ORDINANCE NO. _____

An ordinance amending Title 30 – Residential Code of the Los Angeles County Code by adopting the 2013 California Residential Code by reference, with certain changes and modifications, and making other revisions thereto.

SECTION XX. Chapter 1 is hereby amended to read as follows:

FIGURE R403.1.5

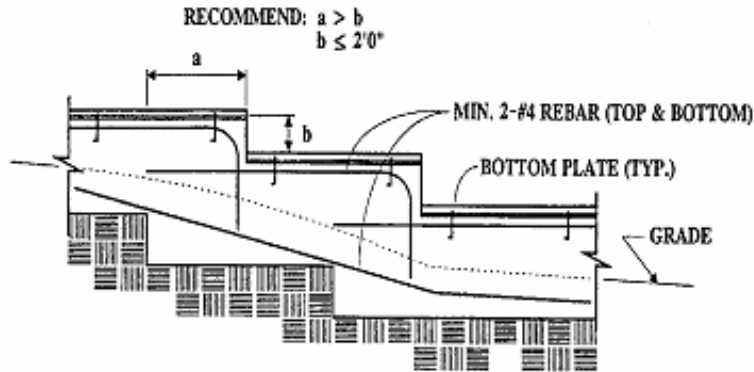
For structures located in Seismic Design Categories D_0 , D_1 , or D_2 , stepped footings shall be reinforced with two No. 4 deformed reinforcing bars located at the top and bottom of the footings as shown in Figure R403.1.5.

Figure R503.2.4

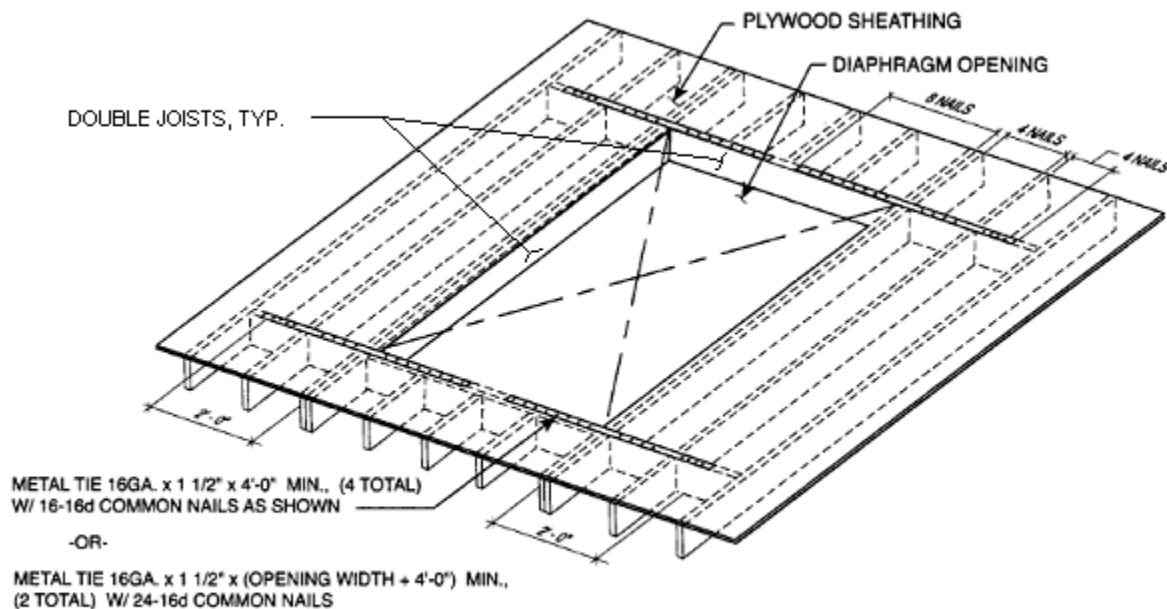
Openings in horizontal diaphragms with a dimension perpendicular to the joist that is greater than 4 feet (1.2 m) shall be constructed in accordance with Figure R503.2.4.

- a. Blockings shall be provided beyond headers.
- b. Metal ties not less than 0.058 inch [1.47 mm (16 galvanized gage)] by 1.5 inches (38 mm) wide with eight 16d common nails on each side of the header-joist intersection. The metal ties shall have a minimum yield of 33,000 psi (227 MPa).
- c. Openings in diaphragms shall be further limited in accordance with Section R301.2.2.2.5.

FIGURE R602.10.6.1
METHOD ABW—ALTERNATE BRACED WALL PANEL

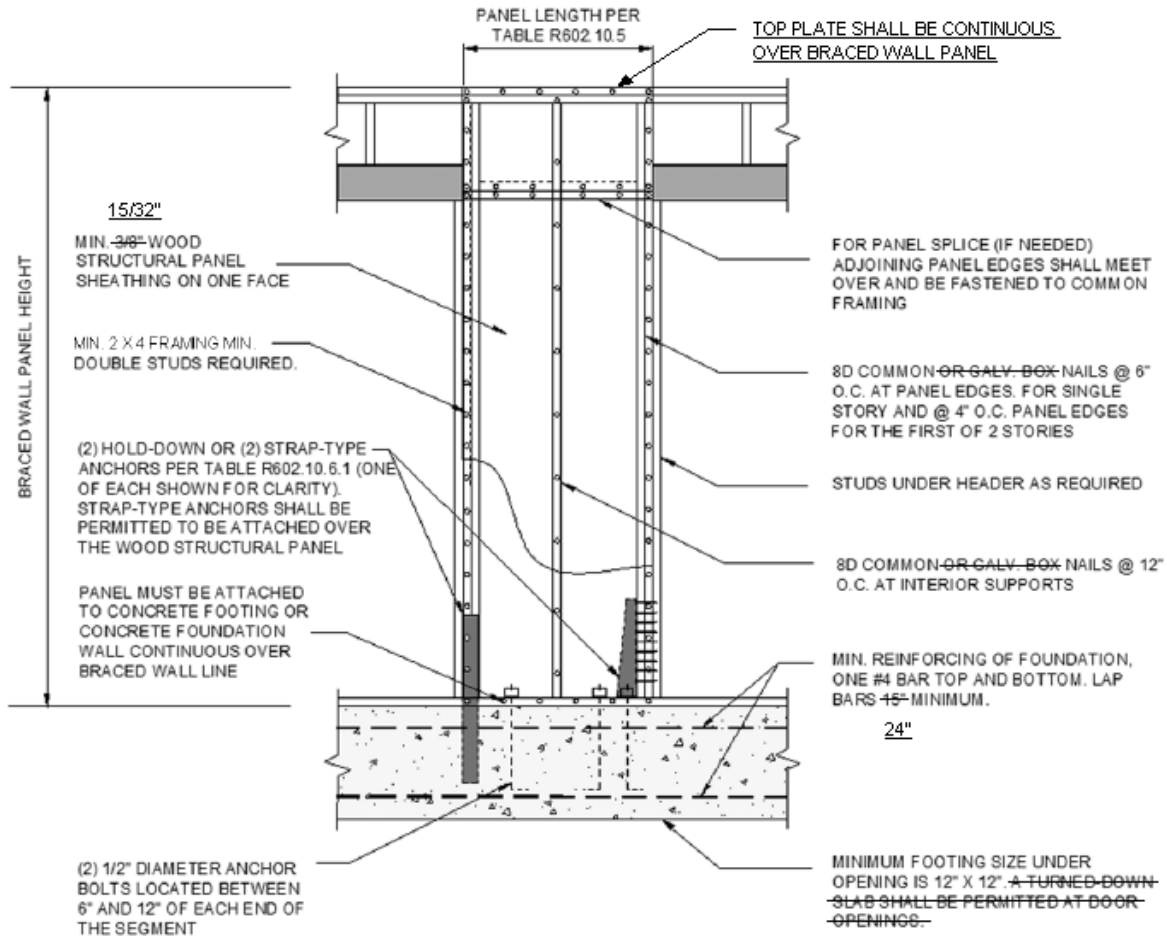
SECTION XX. Figure R602.10.6.1 is amended to read as follows:
